**Town of Nags Head Planning Board
Nags Head Municipal Complex Board Room
Tuesday, September 17th, 2024; 9:00 a.m.**

To: Planning Board
From: Kelly Wyatt, Planning Director
Joe Costello, Deputy Planning Director
Date: September 13, 2024
Subject: Special Use Permit/Site Plan Review, 425 W. Health Center Drive

Purpose/Request: Construction of an approximately 3,460 square feet, two story, eight-bedroom dormitory (duplex) and all associated site improvements. This dormitory is for use by Town of Nags Head workforce or as approved by the Town Manager.

SITE, UTILITY & LANDSCAPING PLAN
OCEAN RESCUE HOUSING
425 HEALTH CENTER DRIVE

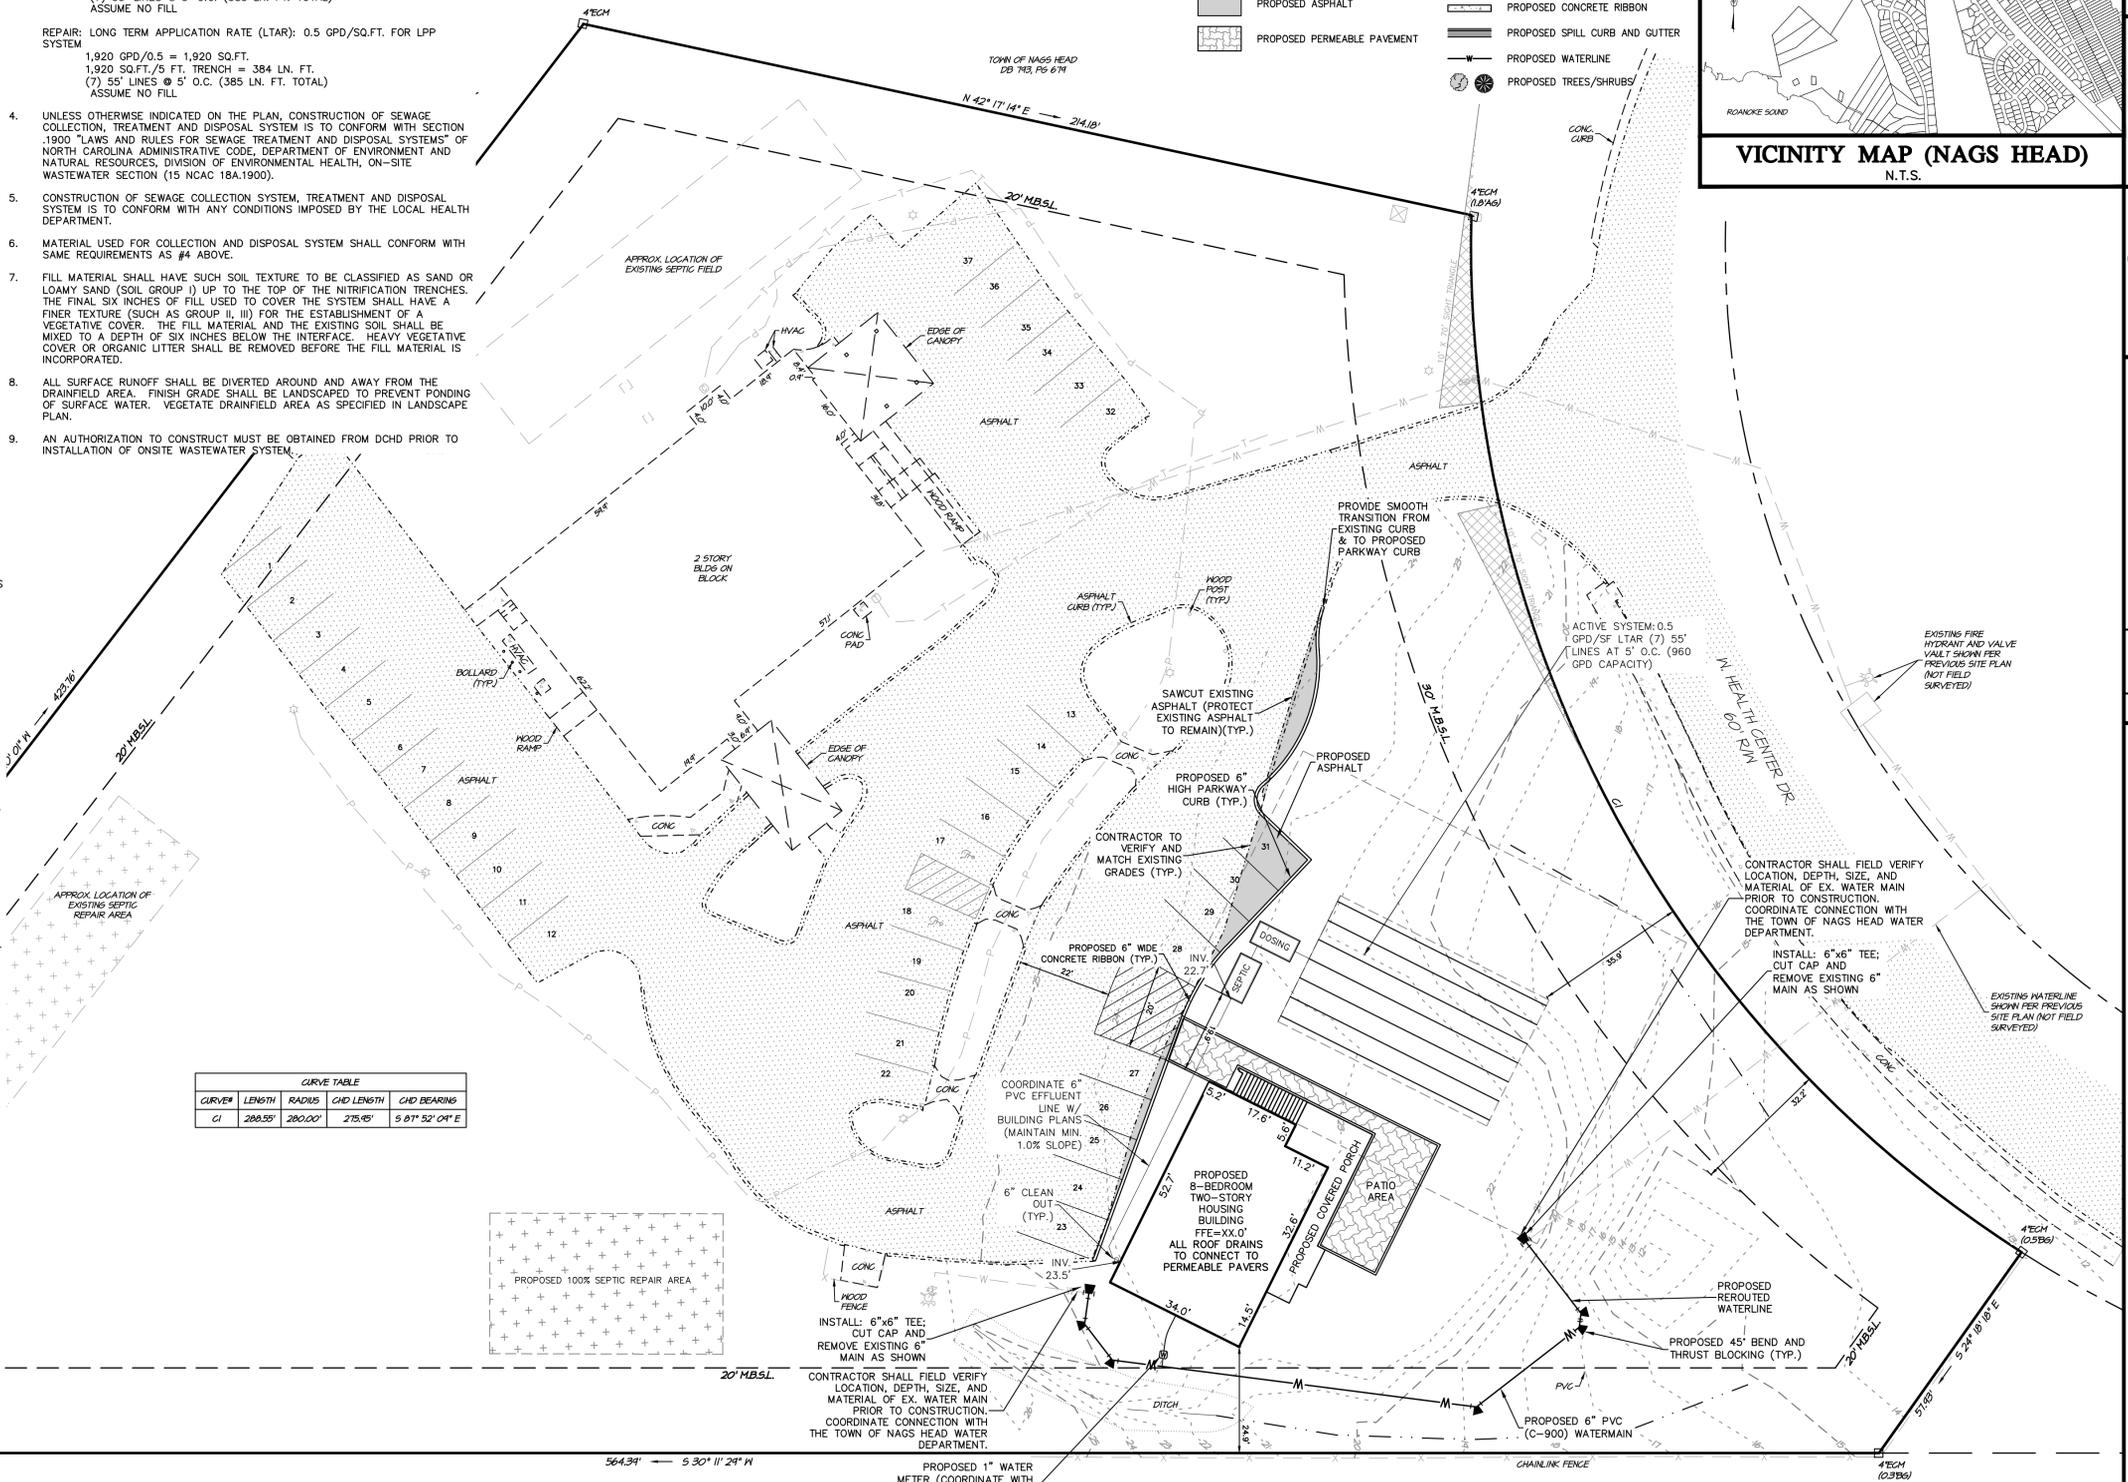
- Lot Coverage: Pursuant to Section 8.4.3.3.6.1 of the UDO, Special Development Standards within the SED-80 (Special Environmental District) the maximum allowable lot coverage for this property is 20% of the total lot area. While the exact lot area remains uncertain, using the most conservative estimate, the current site conditions result in approximately 28.6% lot coverage.

The proposed redevelopment of the dormitory, including the removal of the non-functional helipad and various other improvements, conceptually shows a lot coverage of 29.03%, slightly above the allowable 28.6%. However, we are awaiting an opinion from our town attorney regarding the correct boundary of the property. It is likely that once the property boundaries are confirmed, the total lot area will increase, which would reduce the lot coverage percentage to 28.6% or less. Please note the discrepancy between the property boundaries shown in Dare County records versus those on the survey (attached). This conflict will be resolved before the Board of Commissioners reviews the project, and the property will not be deemed compliant until the lot coverage is confirmed to be 28.6% or less of the total lot area

- Parking: Pursuant to Article 10, Table 10-2, *Required Parking by Use*, dormitory uses are required to provide one parking space for every four occupants. For this structure, which will have a maximum occupancy of 16, a total of four (4) parking spaces are required. However, considering that this structure is intended to house the Town of Nags Head workforce, including seasonal lifeguards, it is

Currently, there are 37 existing parking spaces onsite. Based on a liberal application of the medical office parking standard to the Community Care Clinic, which is also located onsite, we estimate that approximately 25 parking spaces are necessary for the clinic. This leaves 12 parking spaces available for dormitory use, providing parking for three-quarters of the dormitory occupants. Ideally, 16 spaces—one per occupant—would be available for this use.

Staff is requesting that the Planning Board consider applying this shared parking provision to address the four (4) additional parking spaces needed to meet the desired total of 16 spaces for the dormitory. The Community Care Clinic operates between 9:00 AM and 4:00 PM, Monday through Friday, and is closed on weekends. In contrast, the Town's ocean rescue staff typically works from 9:00 AM to 6:00 PM, with some early morning training sessions. Given these staggered hours, there should be minimal overlap in parking demand between the clinic and the ocean rescue staff.

Based upon staff's review of the proposal, we recommend approval of the Special Use Permit/Site Plan Review as submitted conditioned upon the proposed lot coverage not exceeding 28.6%.

1 FIRST FLOOR PLAN
SCALE: 1/4" = 1'-0"

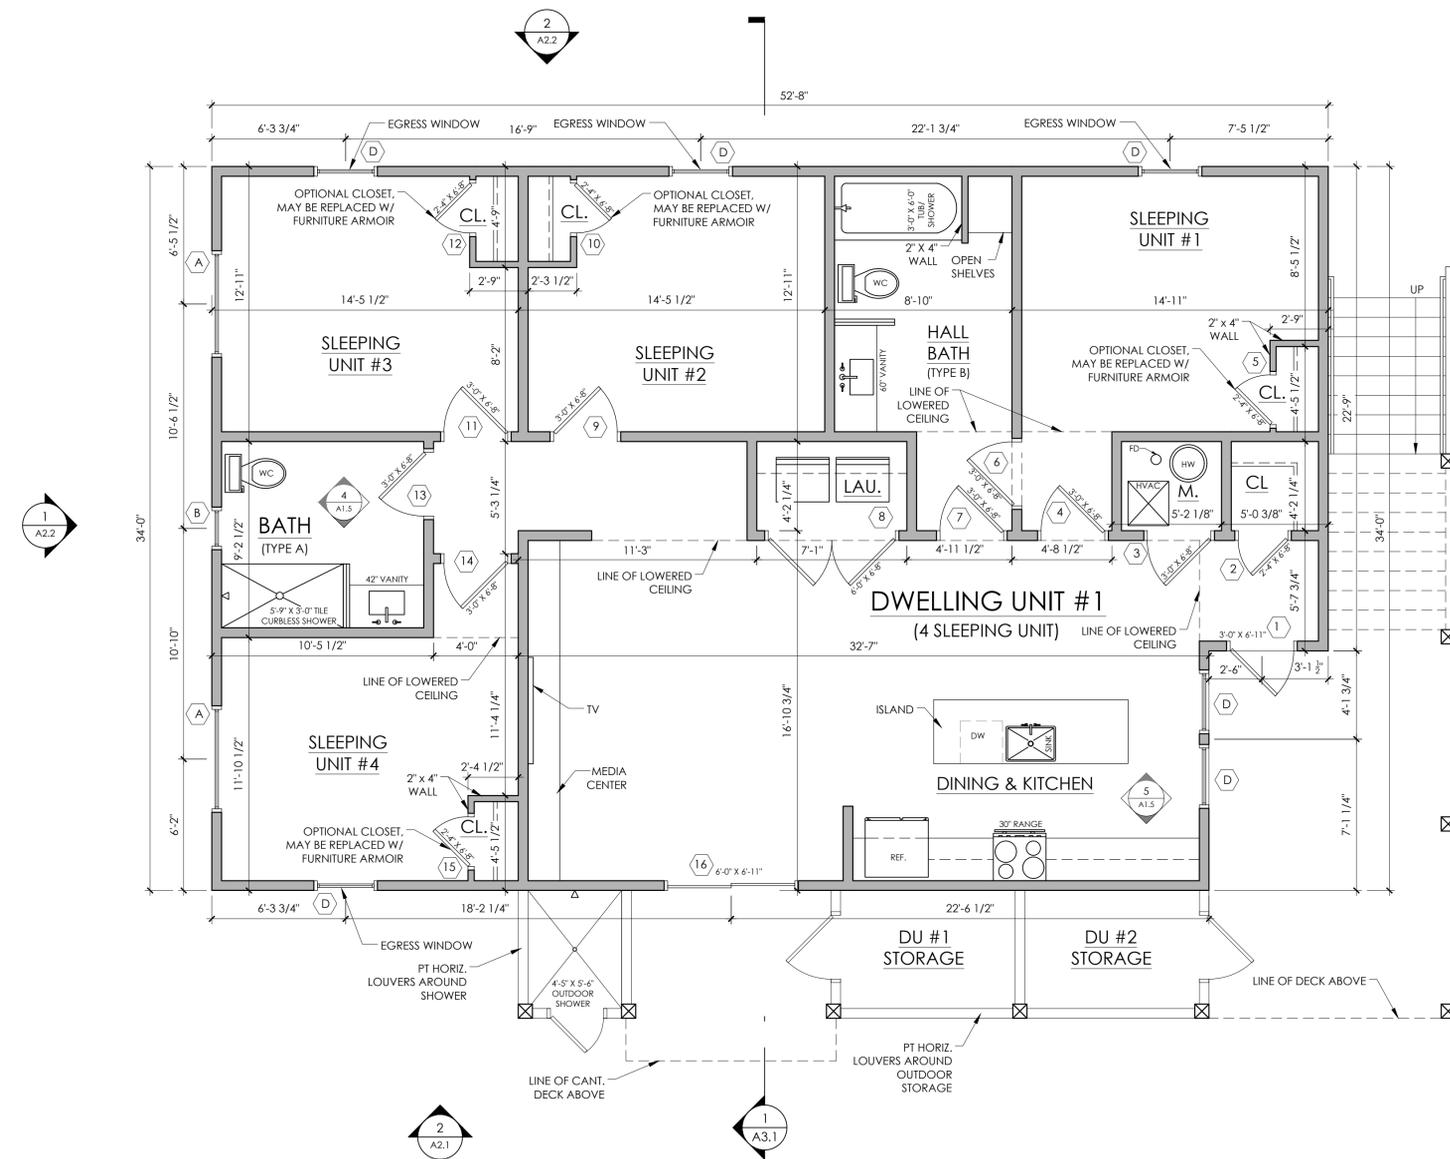
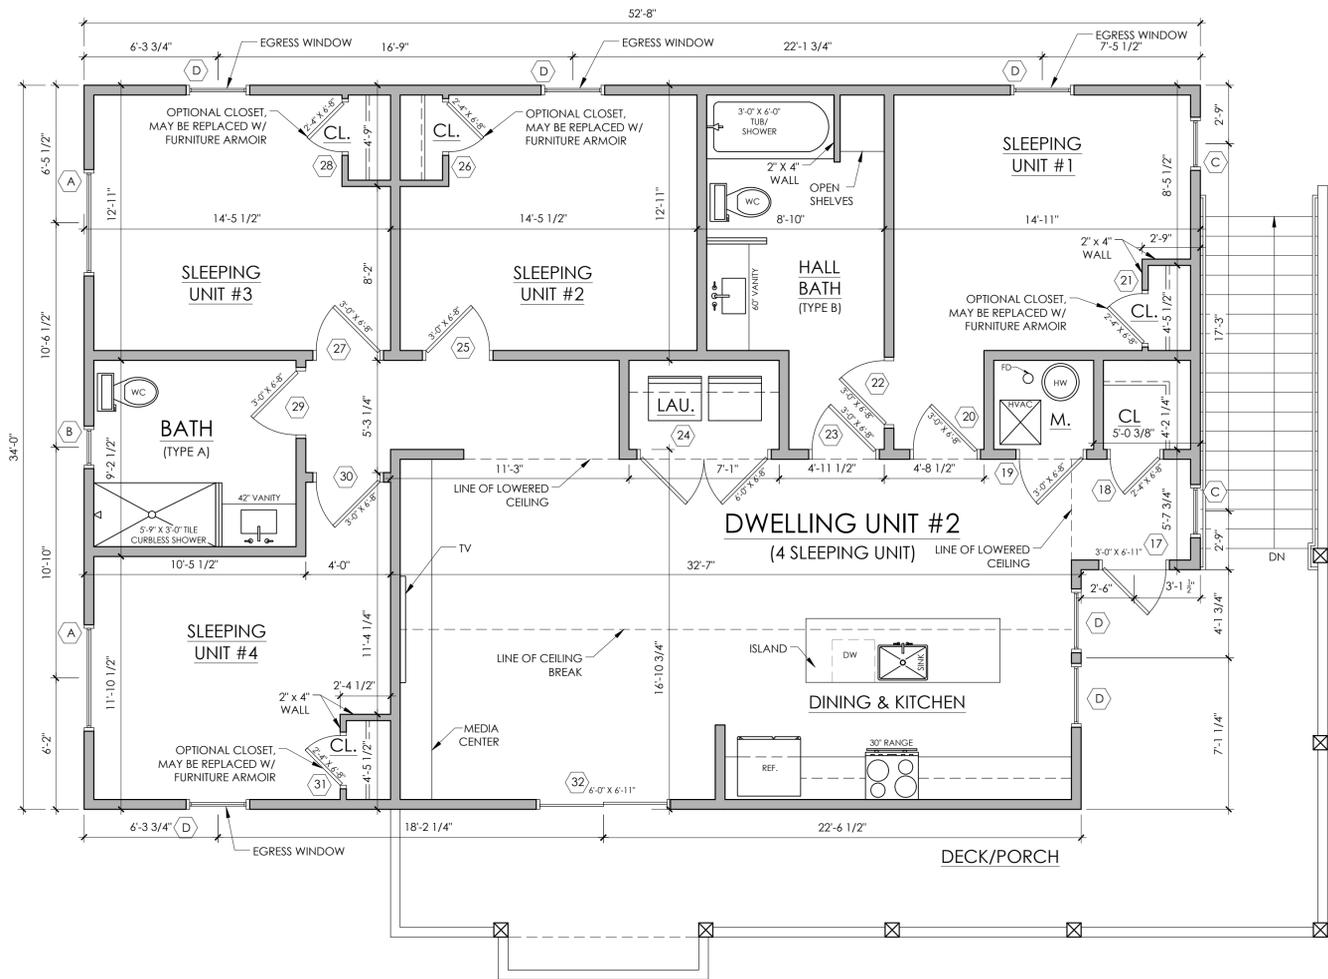
7.10.2. Sleeping rooms shall have a minimum floor area of seventy (70) square feet for the first occupant and a minimum floor area of fifty (50) square feet for each additional occupant. *Staff comment: Each floor contains 4 bedrooms with an expected occupancy of 8, a total of 8 bedrooms with an expected occupancy of 16. The proposed sleeping rooms will accommodate two occupants. Each sleeping room is approximately 170 square feet in area. As proposed, this regulation has been met.*

7.10.3. At least one restroom in the facility shall have a minimum of two (2) water closets, two (2) sinks, and two (2) showers. In all cases, reference the North Carolina Plumbing Code for required number of dormitory bathroom fixtures. *Staff comment: Each dwelling unit contains two full bathrooms for a total of 2 toilets, 2 sinks, and 2 showers. As proposed, this regulation has been met.*

7.10.4. A minimum floor area of twenty (20) square feet per occupant is required for adequate common living areas (including kitchen and dining) but not less than 220 square feet per unit or floor. Circulation spaces less than six (6) feet wide shall not be counted as common living areas. *Staff comment: An area greater than 500 square feet has been provided in each dwelling unit. As proposed, this regulation has been met.*

DRAWING NAME:
EXTERIOR ELEVATIONS

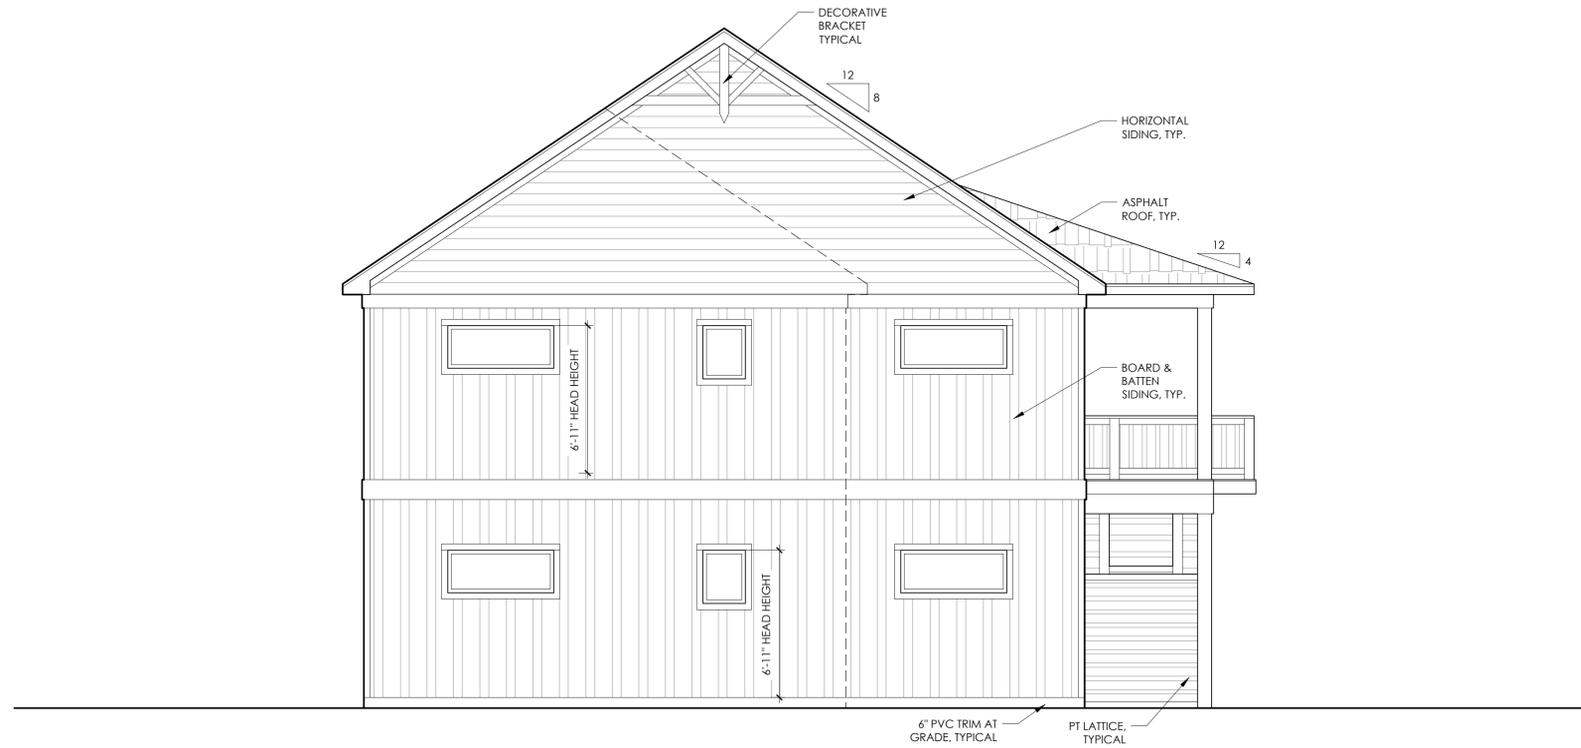
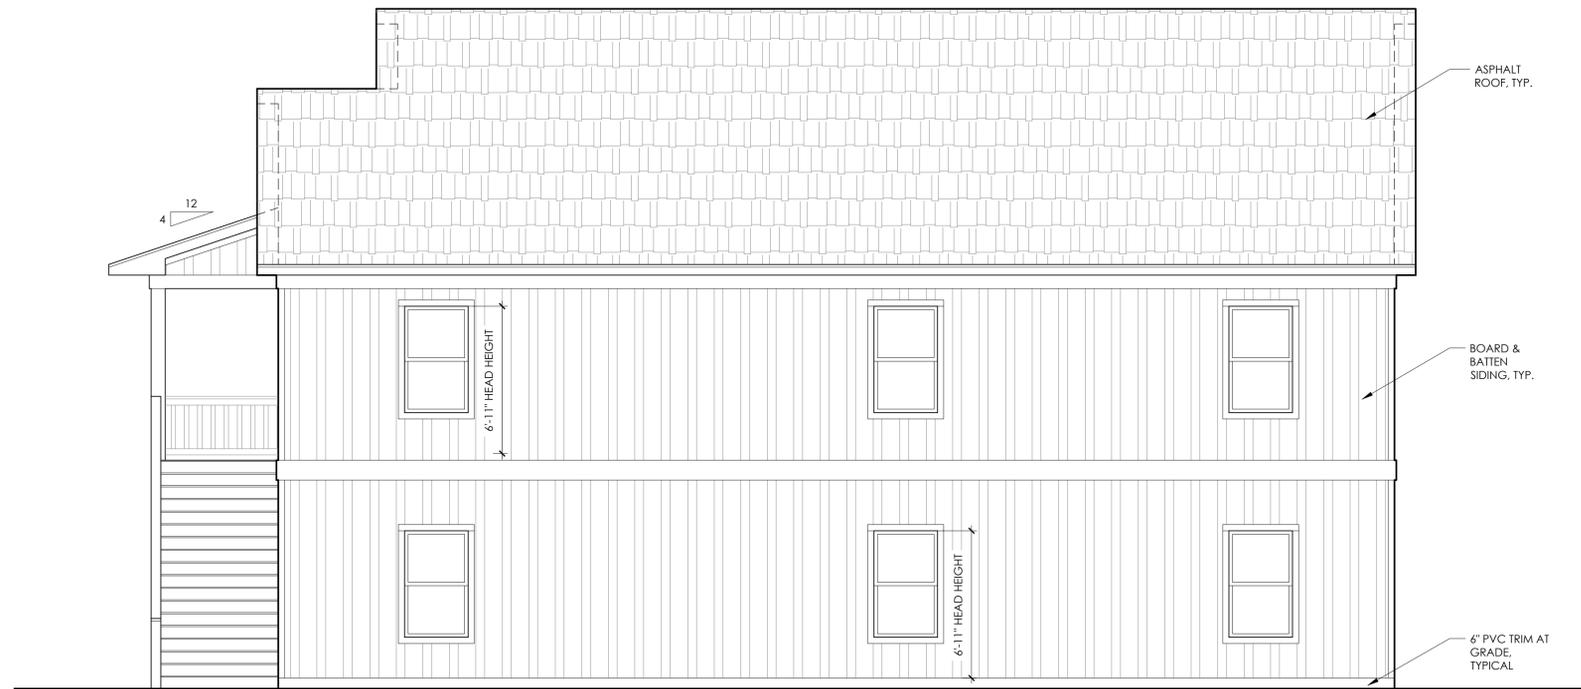
- Height: The maximum allowable building height within the Town is 35 feet; however, pursuant to Section 8.2.1, Dimensional requirements, total height may be increased to 42 feet with the use of an 8:12 roof pitch or greater. The applicant has proposed a structure with an overall height of approximately 32 feet measured from grade, while also proposing an 8:12 roof pitch therefore height is compliant.

- Architecture Design Standards: Section 10.82 of the UDO, Applicability, states that Commercial Design Standards shall apply to all building construction or remodeling projects requiring a special use permit or site plan review. This project must adhere to the Commercial Design Standards set forth within Part VI of the UDO. As proposed this project will comply with standards set forth in Division II – Building Design including a human scale design with a second-floor covered porch, residential style single or double hung windows, board and batten siding, gable brackets, etc. We have requested that the architect incorporate a few other elements such as workable shutters and column trim.
